**STAFF REPORT**  
**COMMUNITY DEVELOPMENT DEPARTMENT**

HEARING DATE: February 17, 2022  
 TO: Planning & Zoning Commission  
 FROM: Sonya Allen, Associate Planner  
 208-884-5533  
 SUBJECT: H-2021-0081  
 Vanguard Village – MDA, RZ, PP, CUP  
 LOCATION: Generally located 1/4 mile south of W. Franklin Rd. and S. Ten Mile Rd., in the middle of Section 15, T.3N. R.1W.

Street Section C

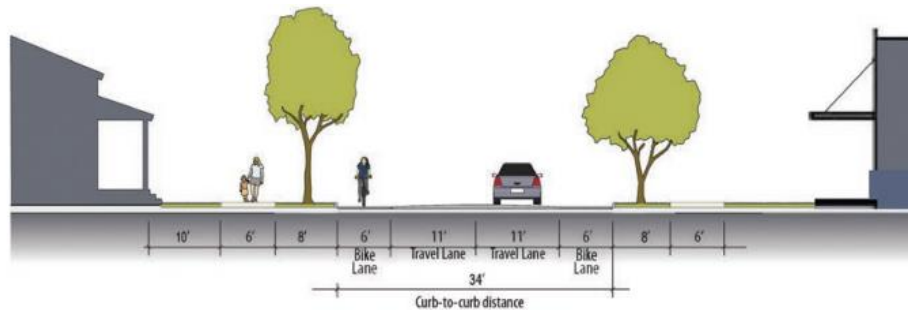
Vanguard Way and Umbria Hills should be constructed in accord with Street Section C (major collector street) in the TMISAP, which requires (2) 11-foot travel lanes, 6-foot bike lanes, 8-foot parkways with streetlights at a pedestrian scale and minimum 6-foot wide detached sidewalks (see pg. 3-20, 3-22, 3-23). The Applicant proposes a modification of the street section with (3) 11-foot travel lanes, 8-foot wide parkways and 10-foot wide detached sidewalks/pathways in lieu of bike lanes, which is required by ACHD. Staff is supportive of this change.

- e. The street sections for Vanguard Way and Umbria Hills shall be constructed in accord with Street Section C (major collector street) in the TMISAP with a modification that allows (3) 11-foot travel lanes, 8-foot parkways and detached 10-foot wide sidewalks/pathways in lieu of on-street bike lanes as required by ACHD. Streetlights are required at a pedestrian scale (see pg. 3-20, 3-22, 3-23).

## 1. Preliminary Plat & Phasing Plan (date: 11/17/2021)

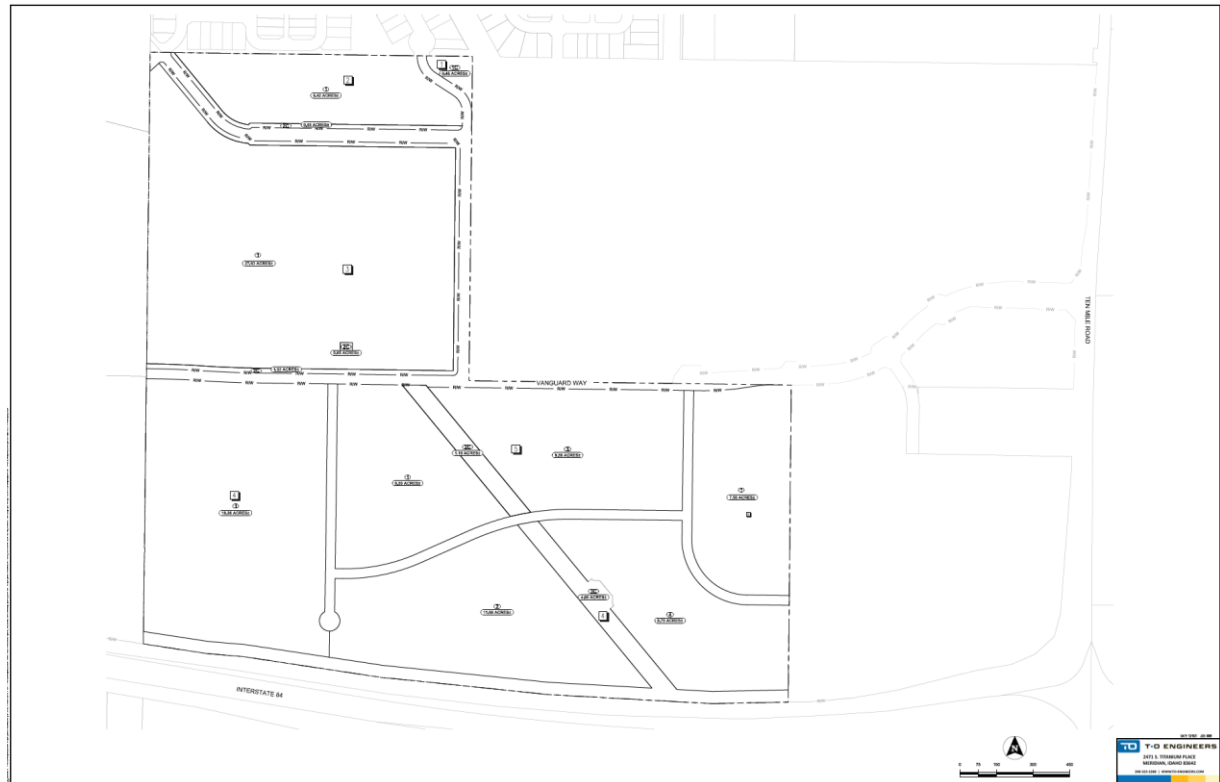
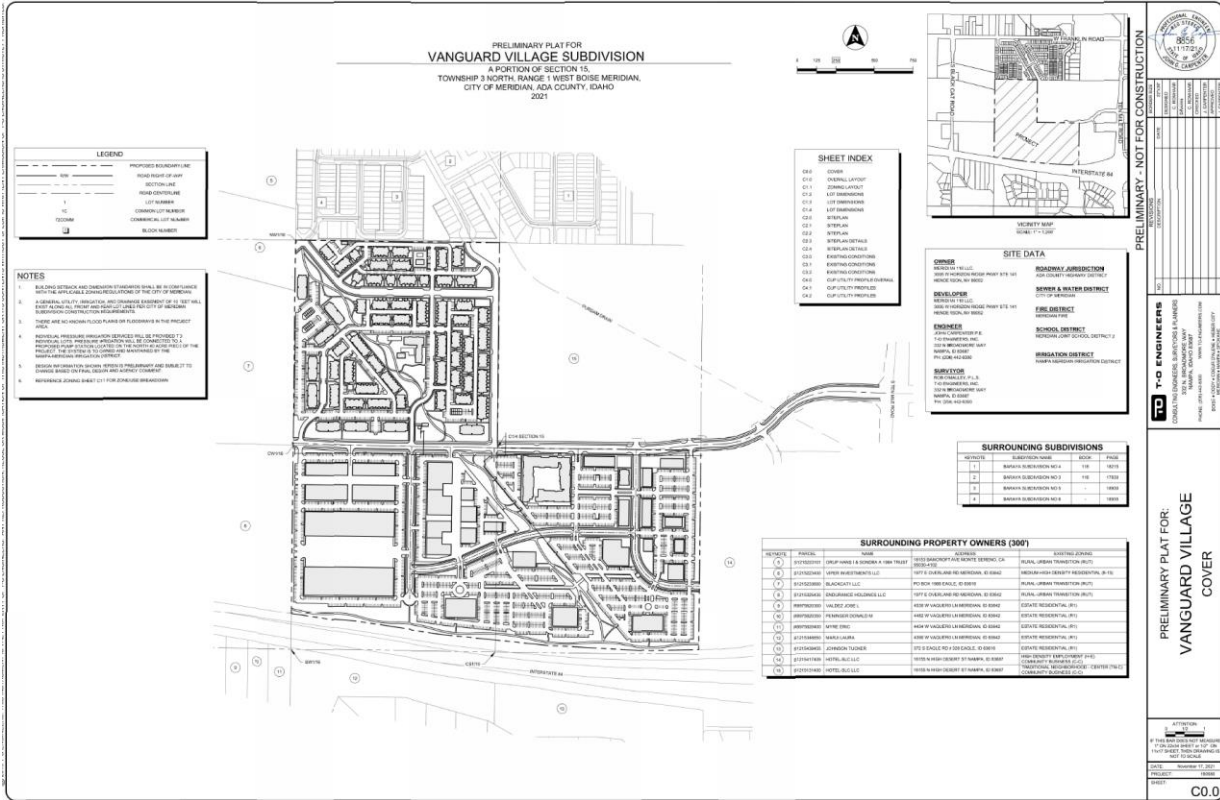
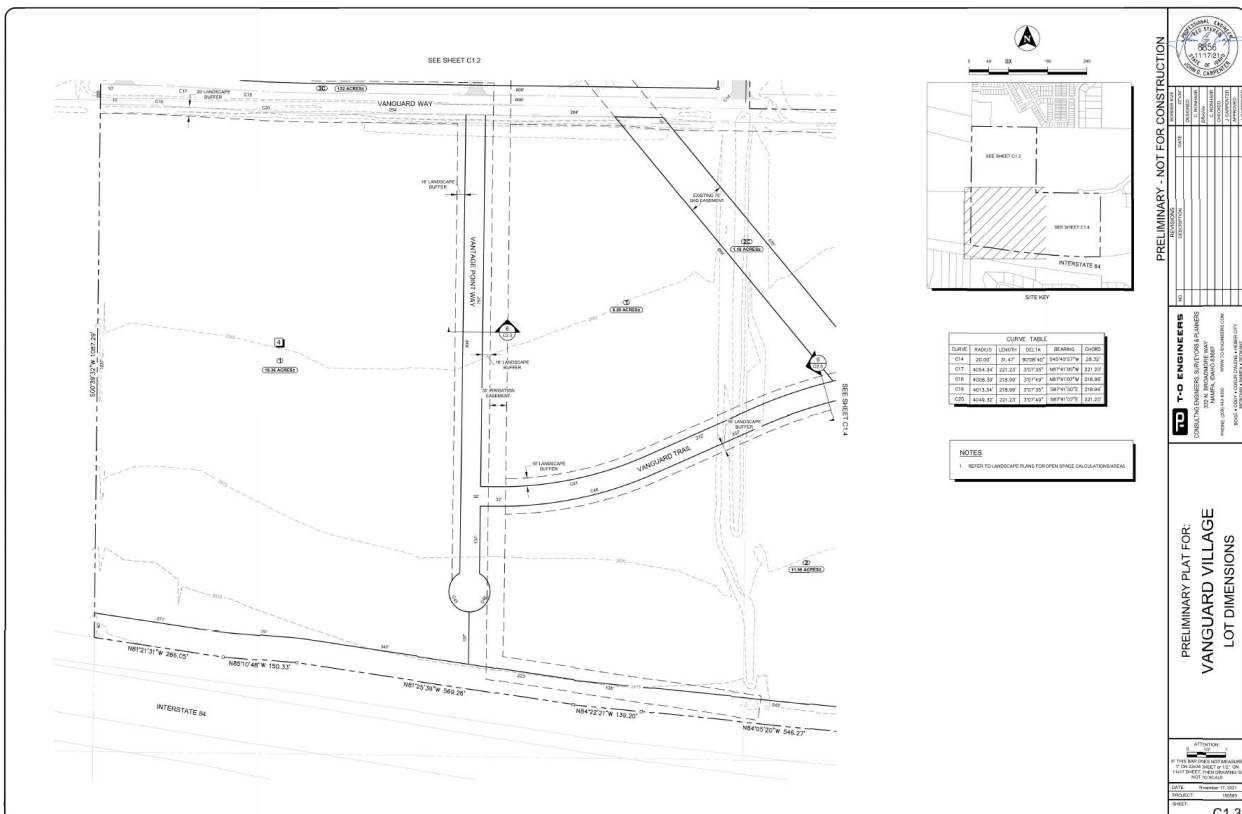
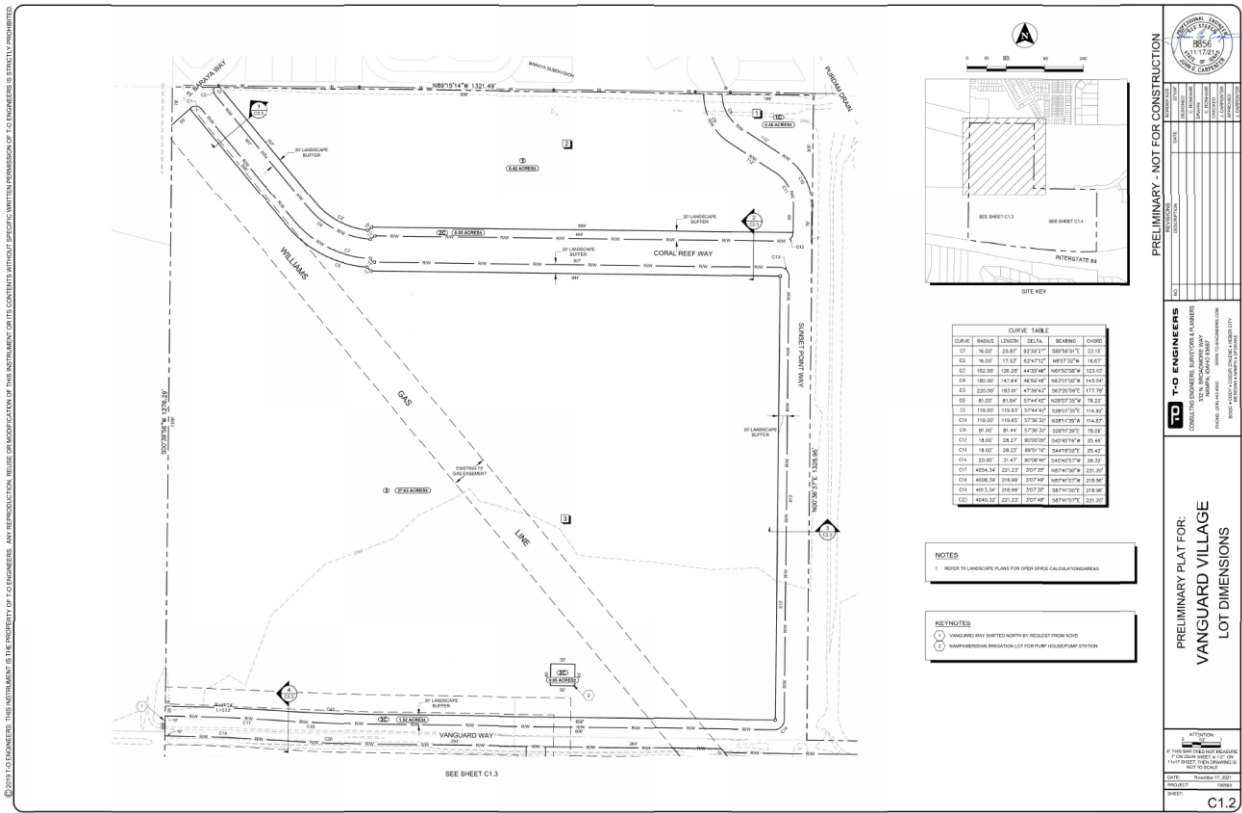
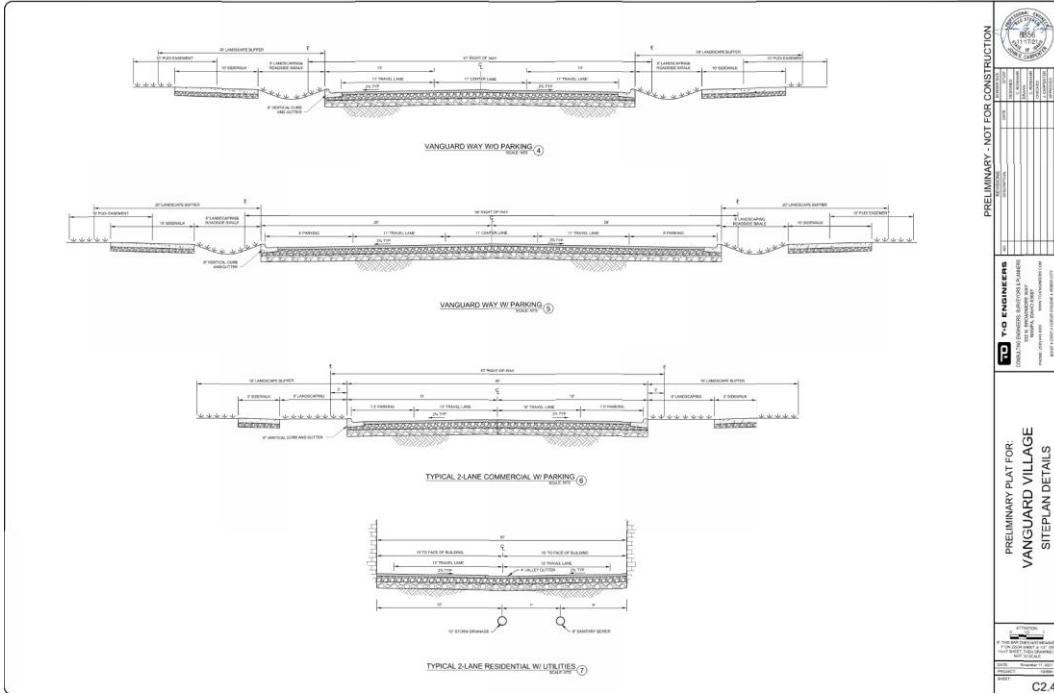
**Streets:** Sunset Point Way and Coral Reef Way should be constructed in accord with Street Section D (residential collector street) in the TMISAP, which requires (2) 11-foot travel lanes, 6-foot bike lanes, 8-foot parallel parking, 8-foot parkways and minimum 6-foot wide detached sidewalks (see pg. 3-21 and 3-23). Streetlights should be placed in the dry utilities' corridor on either side of the street. **The plat should be revised consistent with Street Section D.**

- c. Depict street sections for Sunset Point Way and Coral Reef Way consistent with Street Section D in the TMISAP (see pg. 3-21).
- d. Depict street sections for Vanguard Way and Umbria Hills consistent with Street Section C in the TMISAP with a modification that allows (3) 11-foot travel lanes, 8-foot parkways and detached 10-foot wide sidewalks/pathways in lieu of on-street bike lanes as required by ACHD. Streetlights are required at a pedestrian scale (see pg. 3-20, 3-22, 3-23).
